HPI wants to apologize for a mistake in our production process.
In the most recent batch of 210 type stators, the blue and white wire are swapped.
However, you can easily fix this error by swapping the blue and white wire in the 3-pole connector.
Please check your stator connection before installing and using the ignition.

Stator picture:

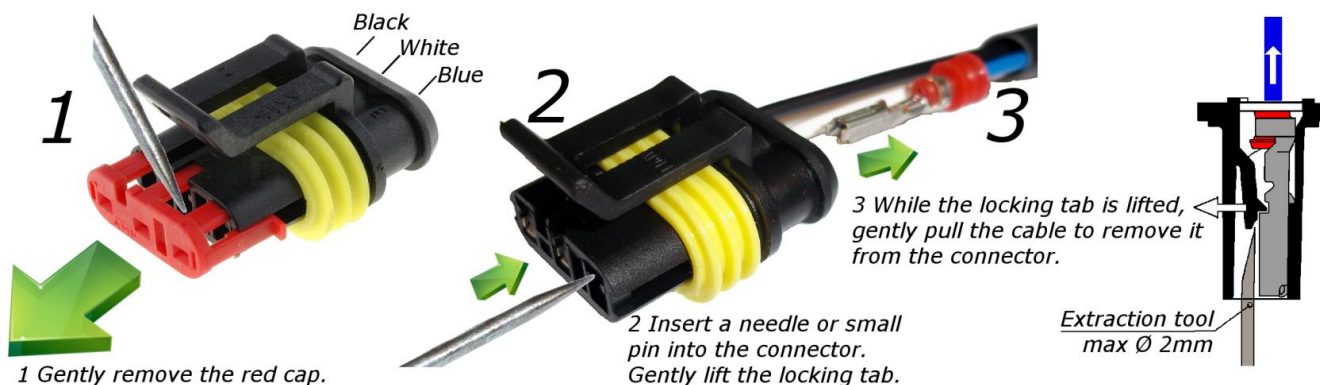
Check the stator:

- Turn the stator upside down.
- Check the position of the white and blue cable on the stator side.
- Check the position of the white and blue cable on the connector side.
- Compare with the drawing on next page.
- If necessary → Swap white and blue in the connector.

- The pictures below show the correct stator – connector combinations.
- Hold the stator upside down.
- Hold the locking lip of the connector on top.
- If your wiring differs from one of the situations below,
→ **swap the blue and white cable in the connector**
